ADDENDUM NO. 2

September 30, 2022

Woods Lake - A Magnet Center for the Arts Remodeling & Site Improvements

**Woods Lake Elementary
3215 Oakland Drive
Kalamazoo, MI, 49008**

WOOD TRIM TO
MATCH ORIGINAL
TRIM THROUGHOUT
THE BUILDING

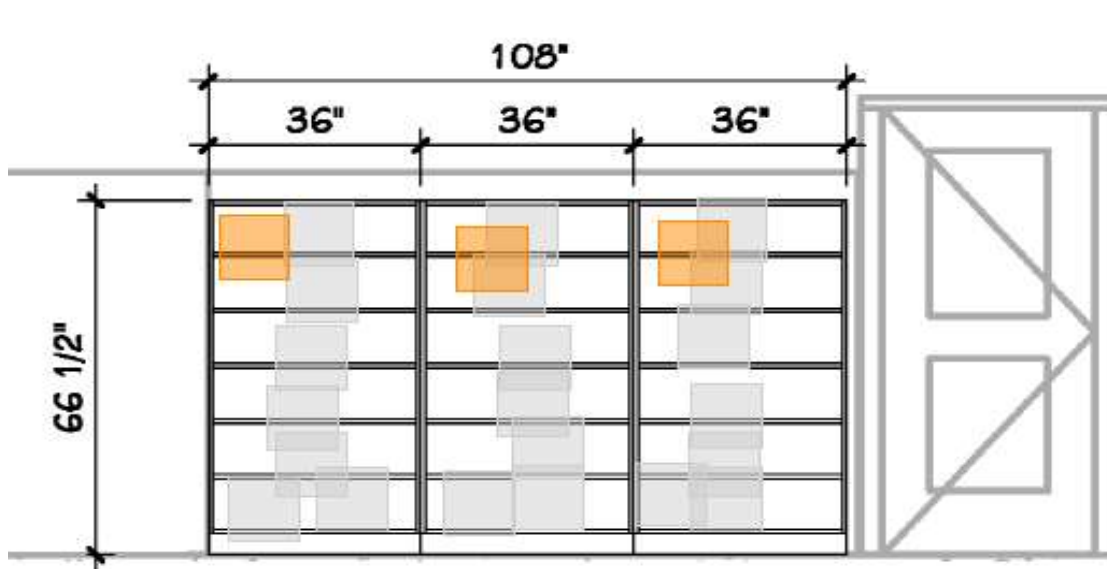
| 37 | Woodsmiths Custom Millwork | 9/28/2022 | I have a question on this project, see attached.. the wood trim is called out for the 72" wide bookcase area, but not for the 108" area. Should there be trim on both areas? Also, do you have a picture of what this trim looks like? I need to know size, wood species, etc. for this trim. | TP: Trim is only required in the classrooms listed on the drawings on the interior elevations. RFI 37 ATTACHMENT INCLUDED IN ADDENDUM 02. | LD |

Refer to Sheet(s): Refer to reissued sheets C 600

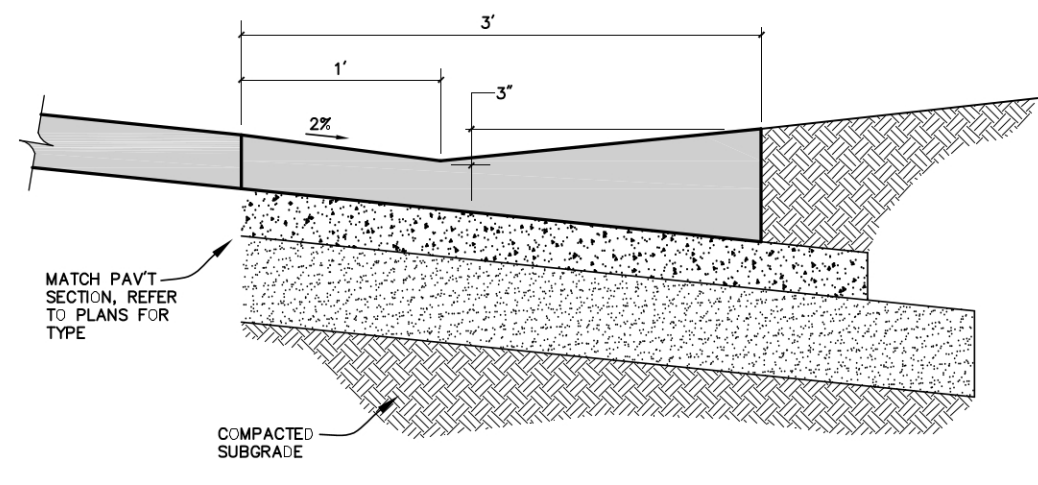
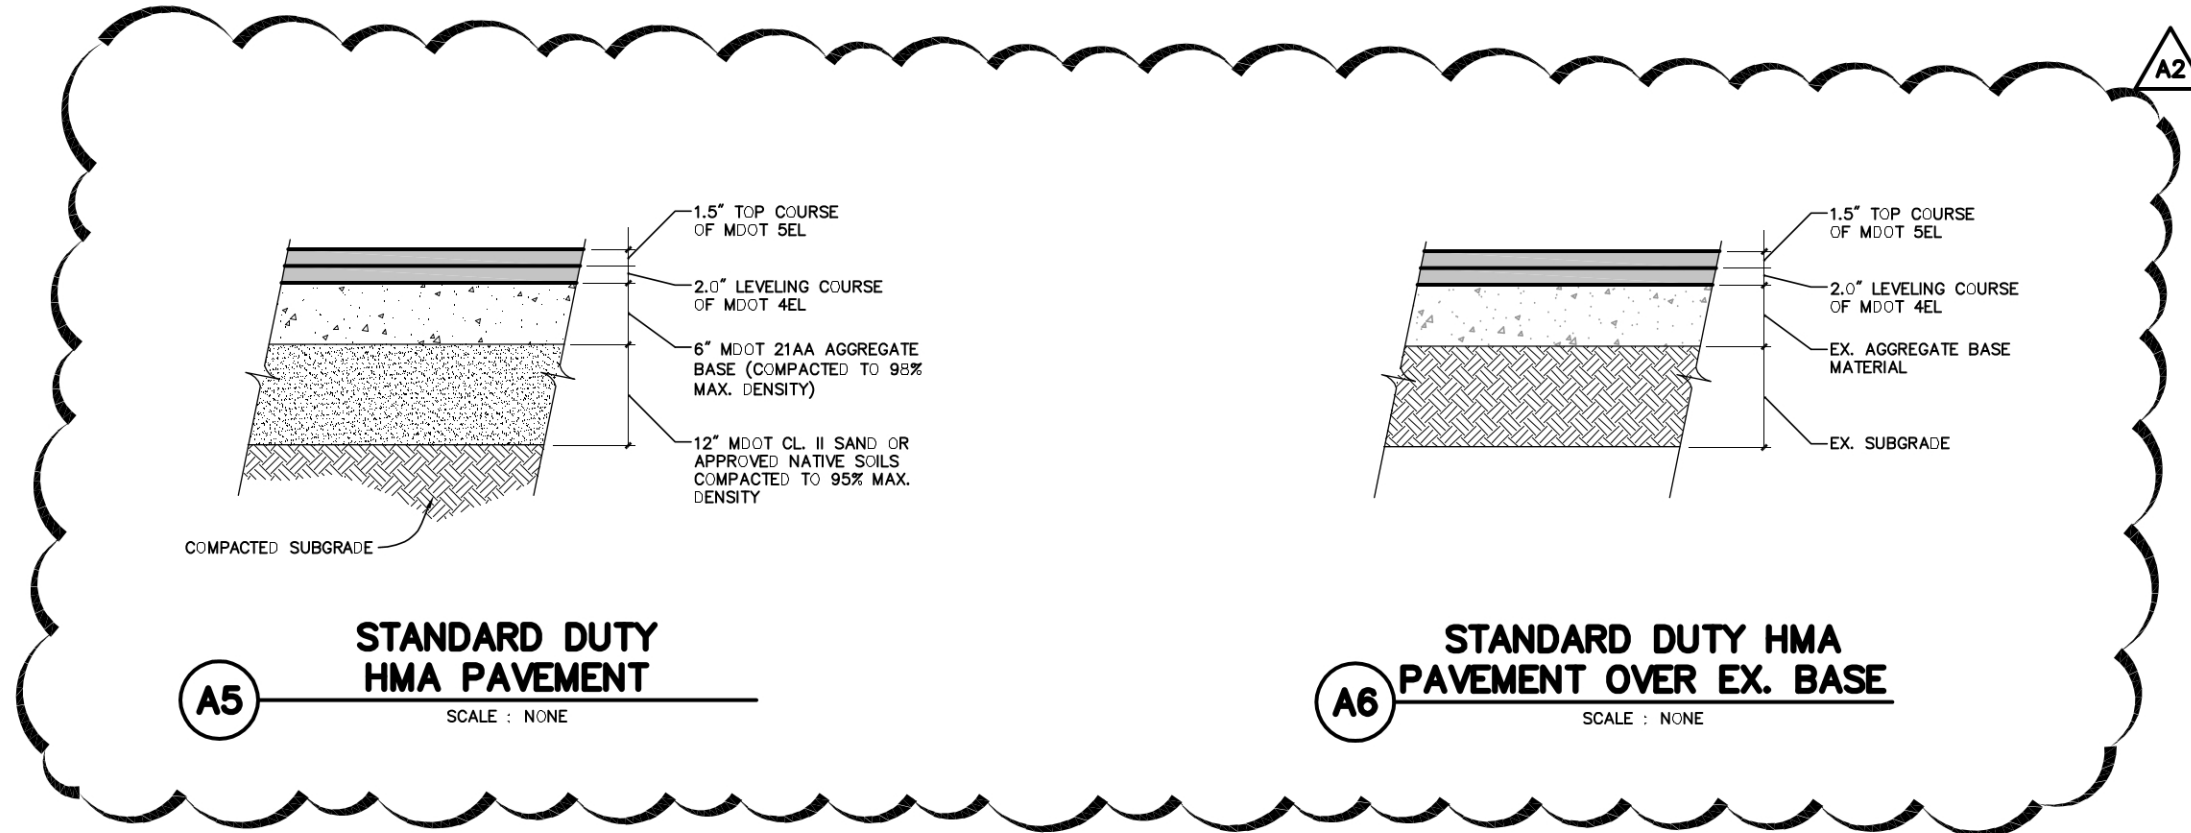
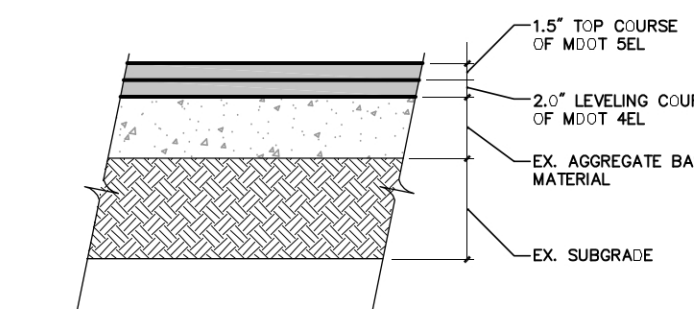
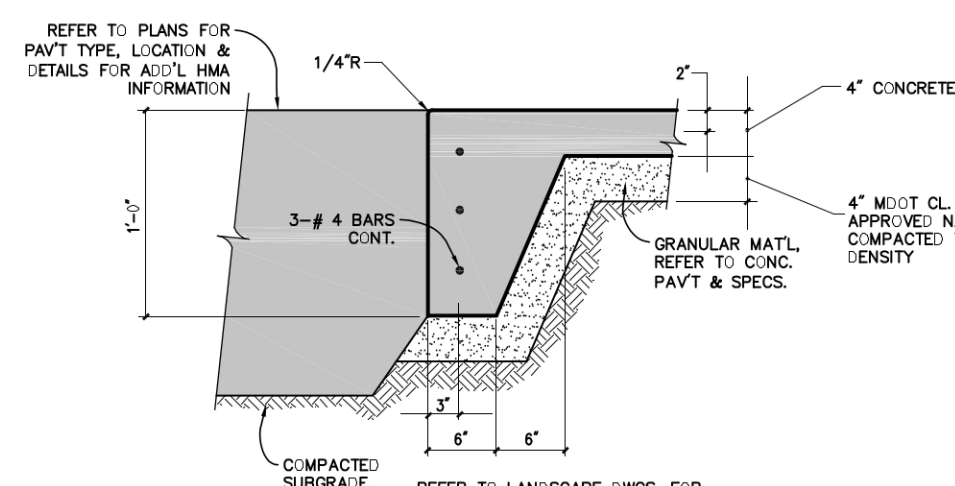
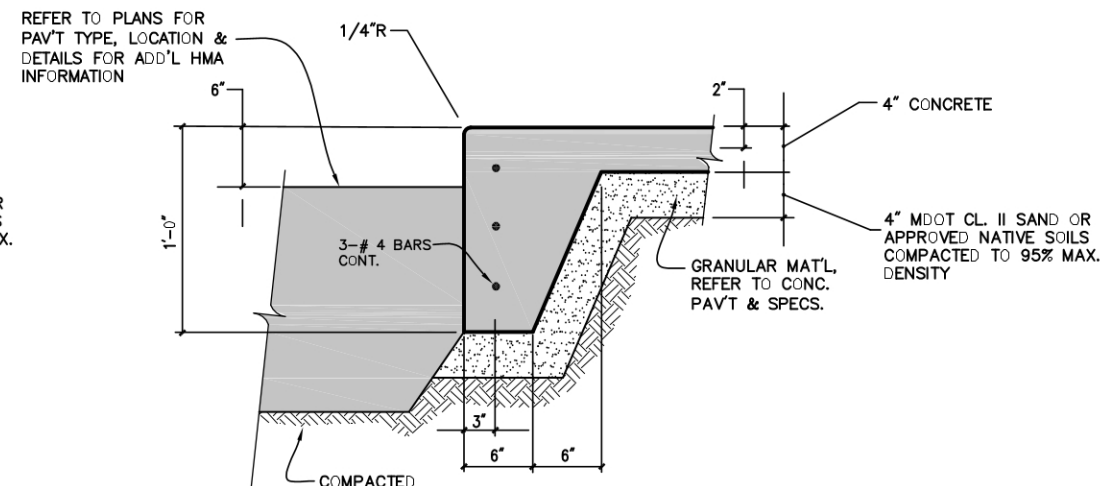
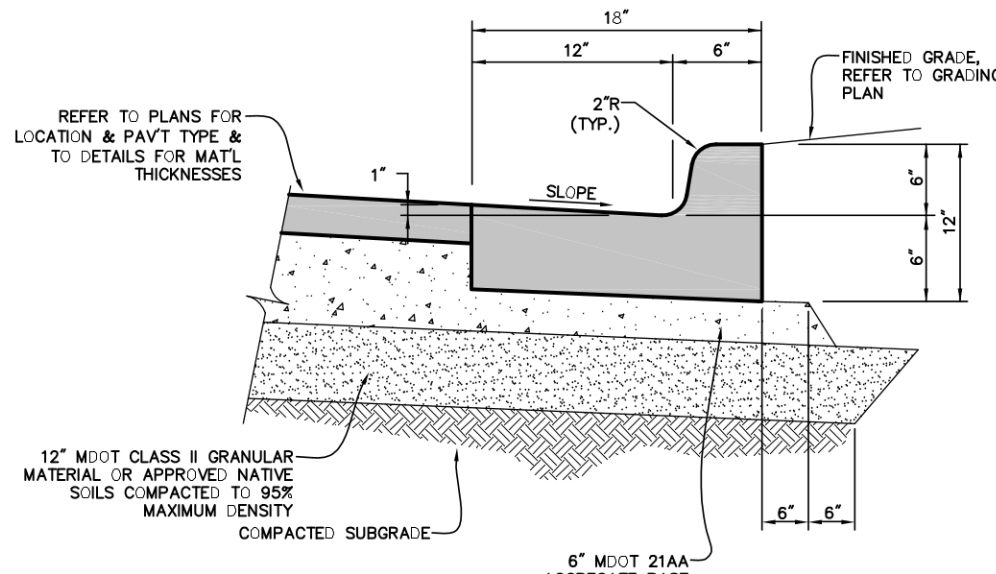
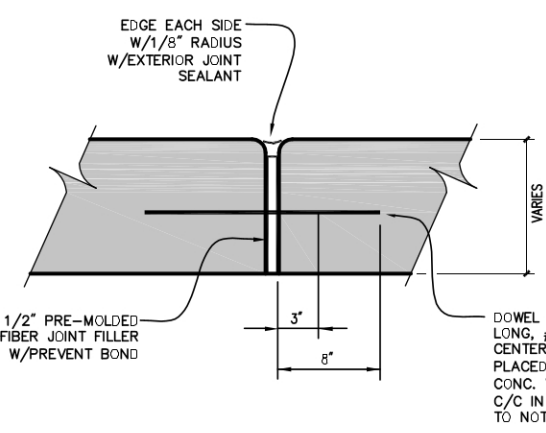
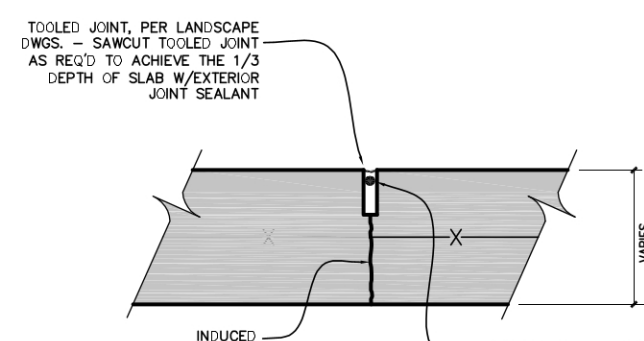
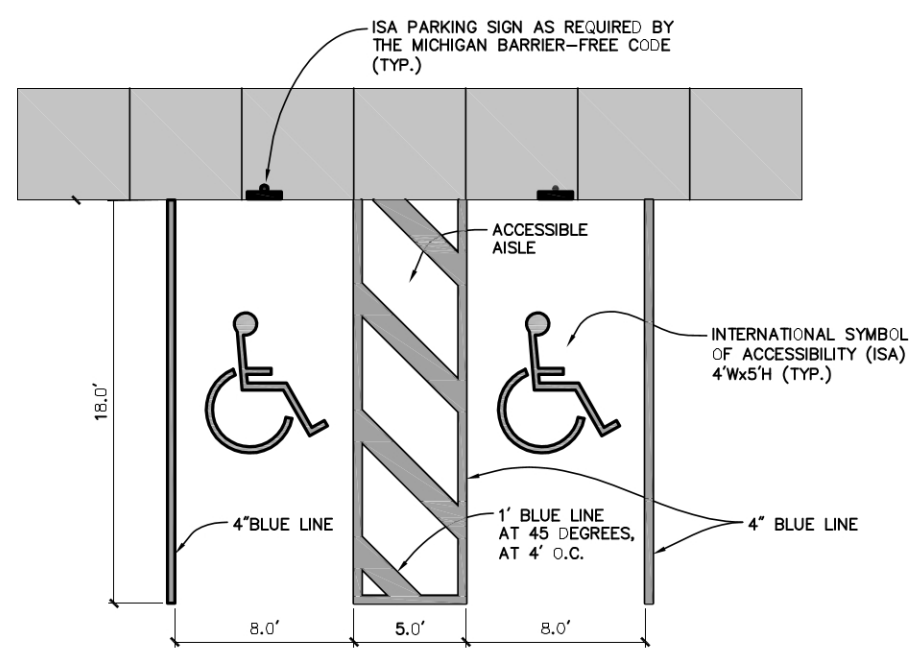
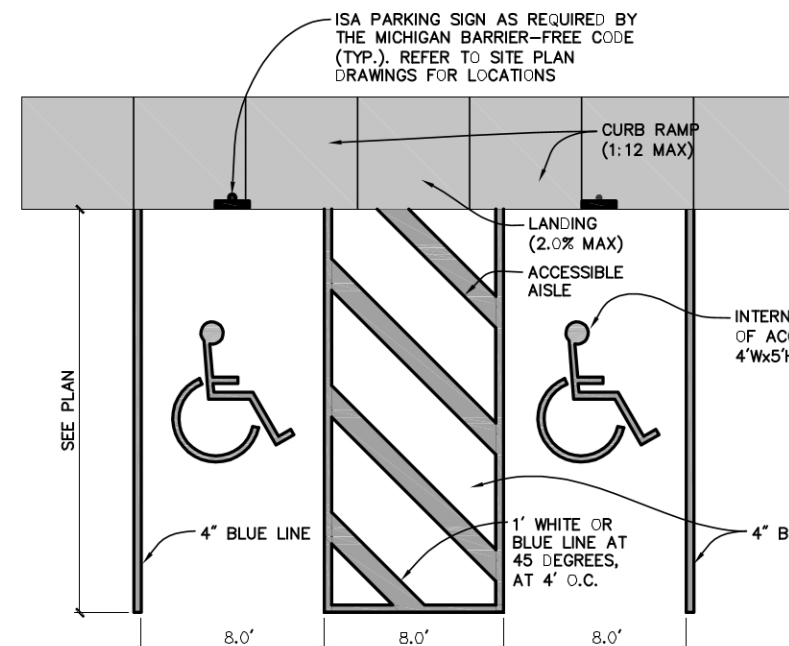
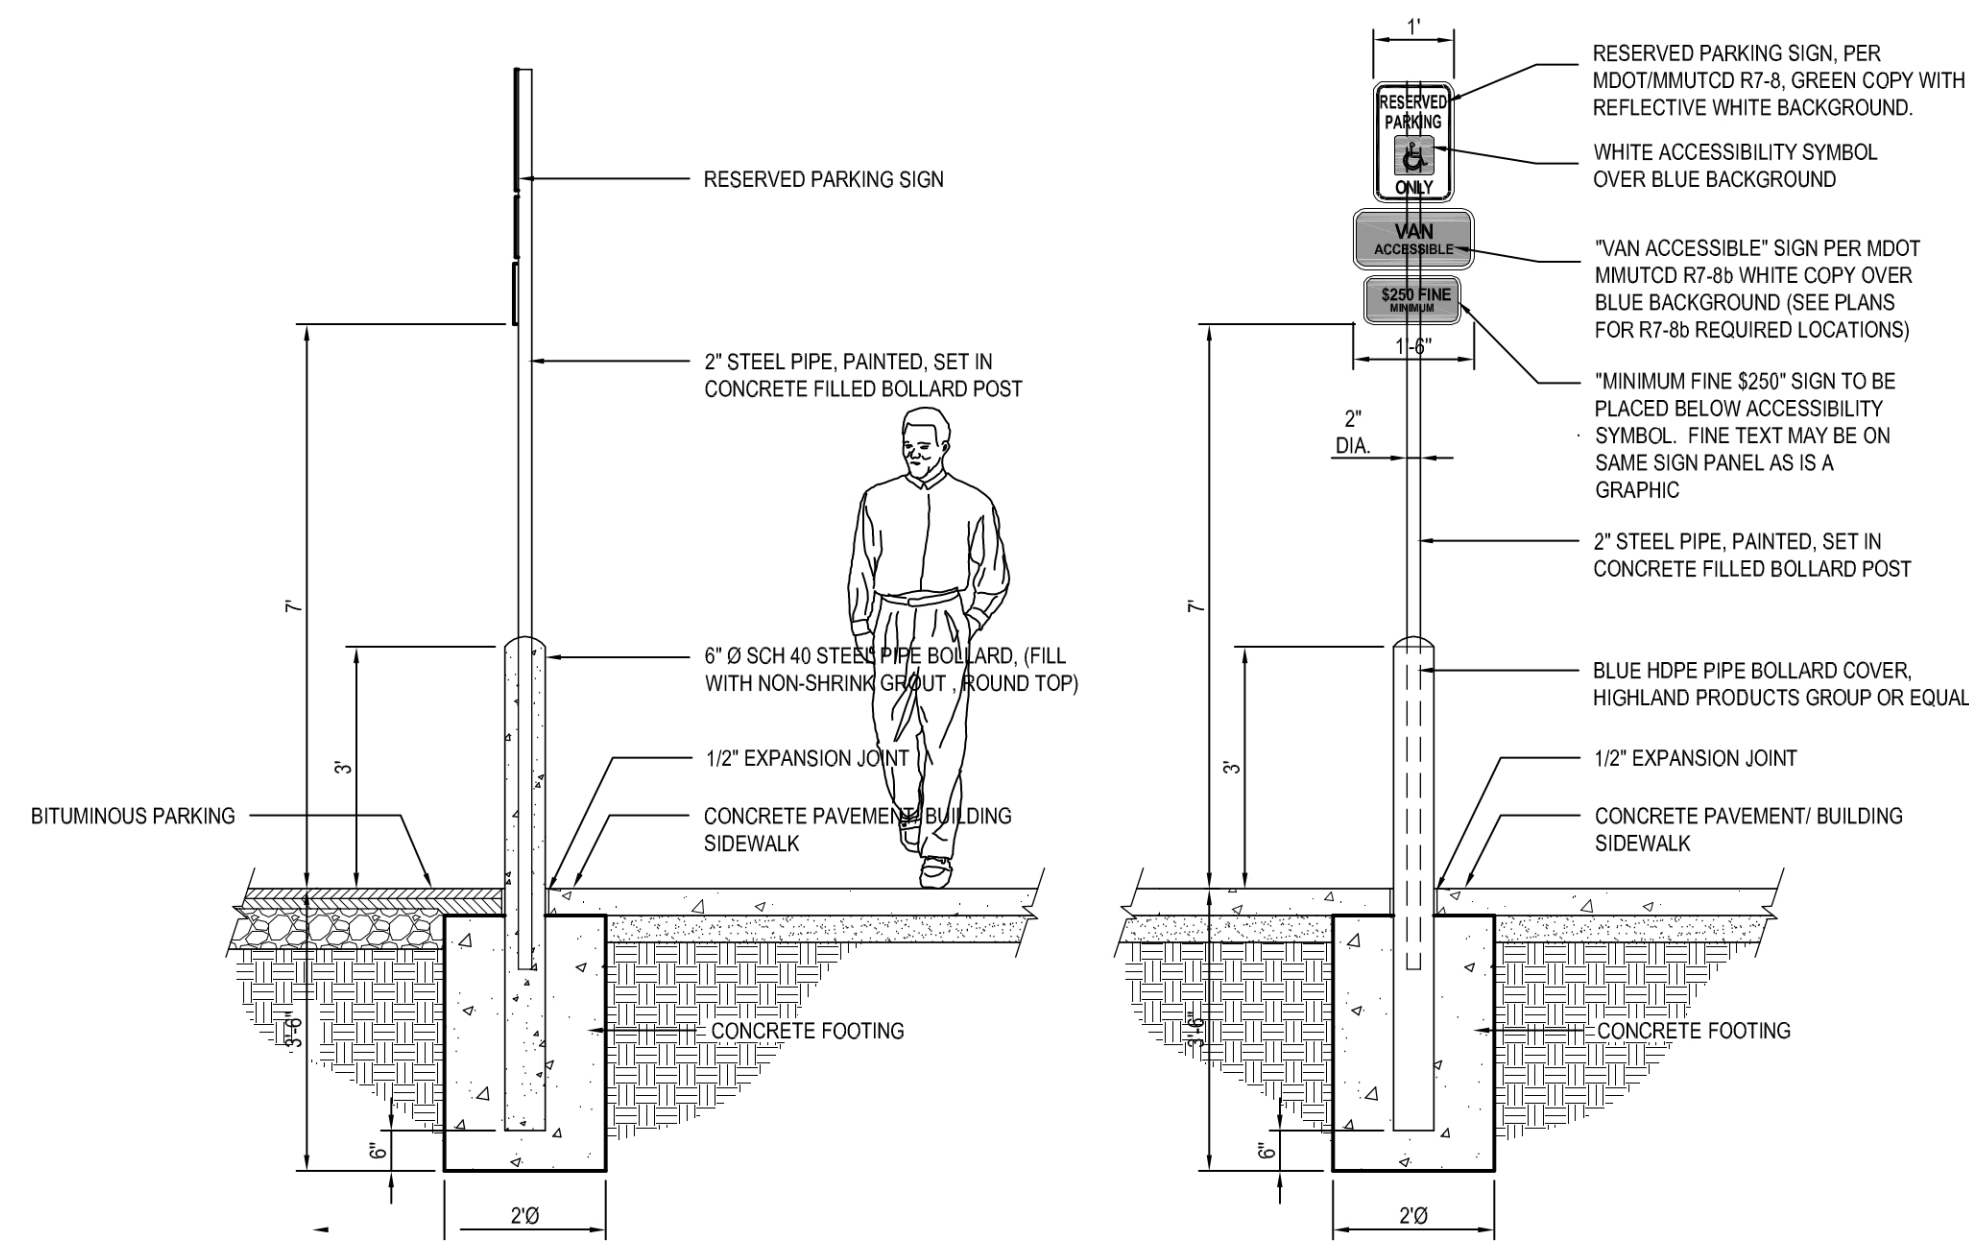
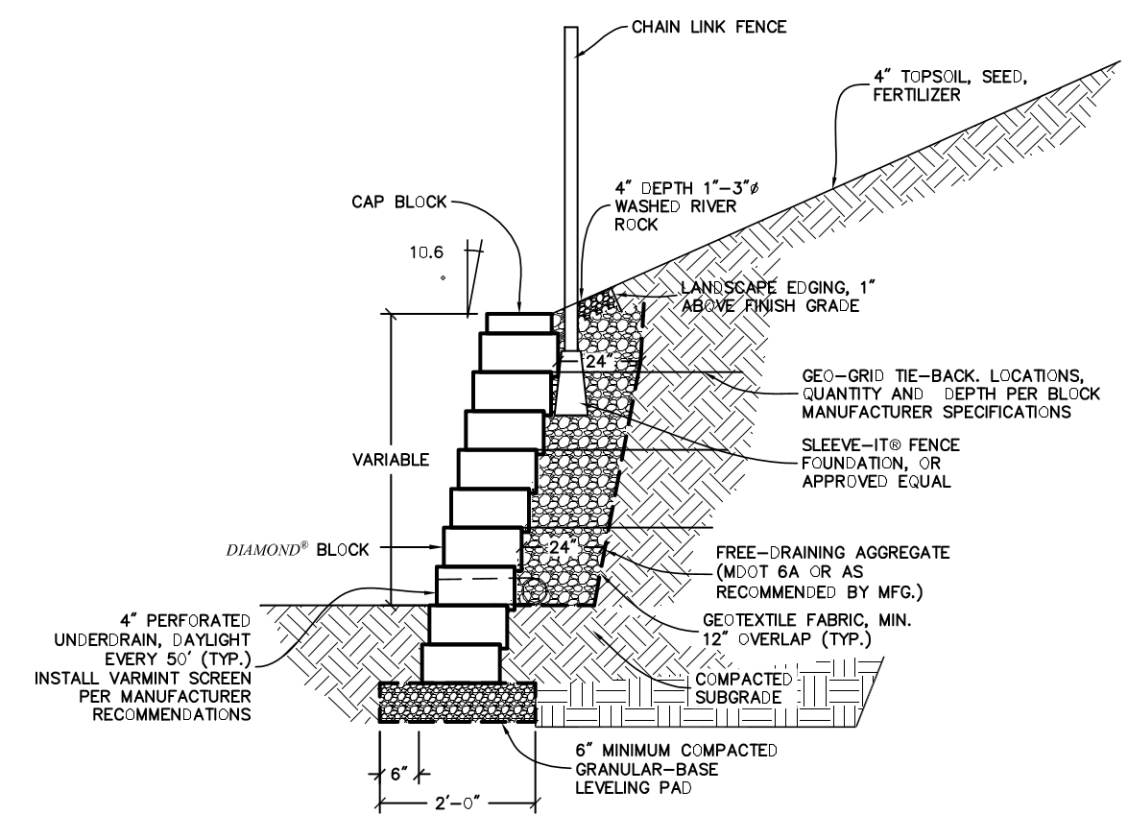
ADD-2 Item No. D-13 - Asphalt Paving Details

Revised asphalt paving details.
